Shafi Knit Ltd.

12th May 2019

Observations

Cantilever beam on roof floor beam

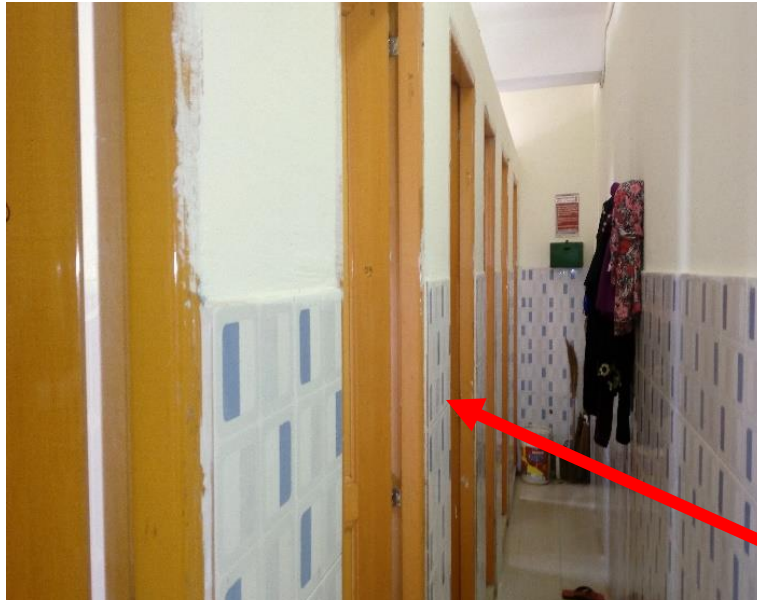
Cantilever beams were found only at 3rd floor roof. A Typical Floor Beam Layout Plan shows cantilever beams. In addition, beam down stand was measured 200 mm instead of 250 mm (as per provided as-built drawing) at 1st to 3rd floor beams.

Toilet Zone

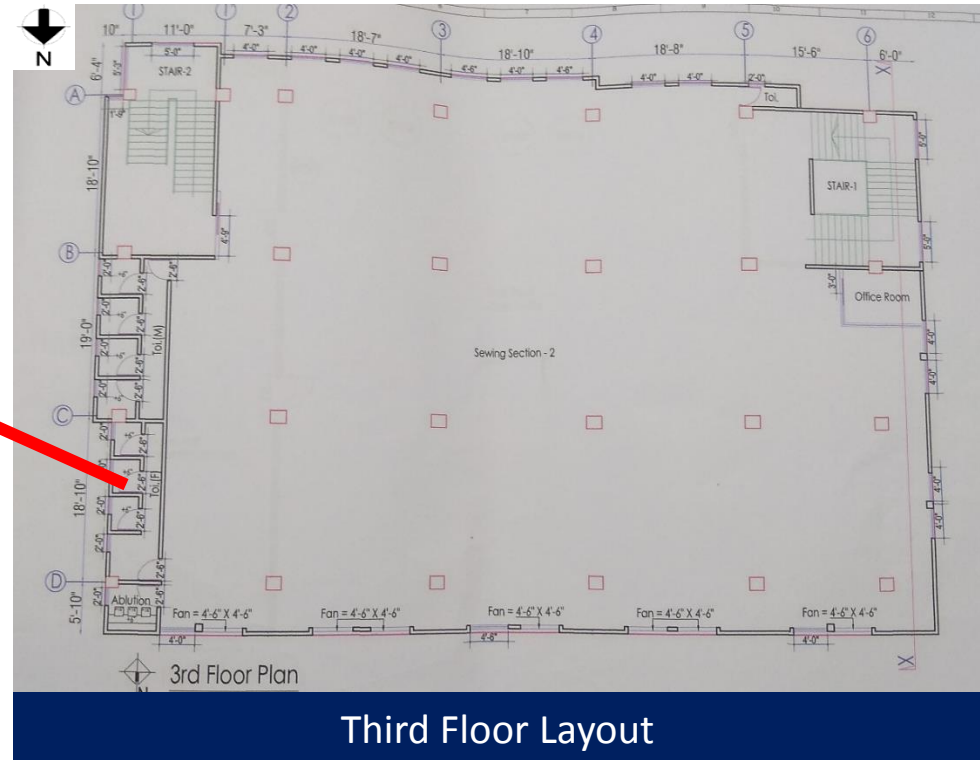
Number of toilets did not match with as-built drawings. Six nos. of female toilets were found on site where as-built drawing shows three nos.
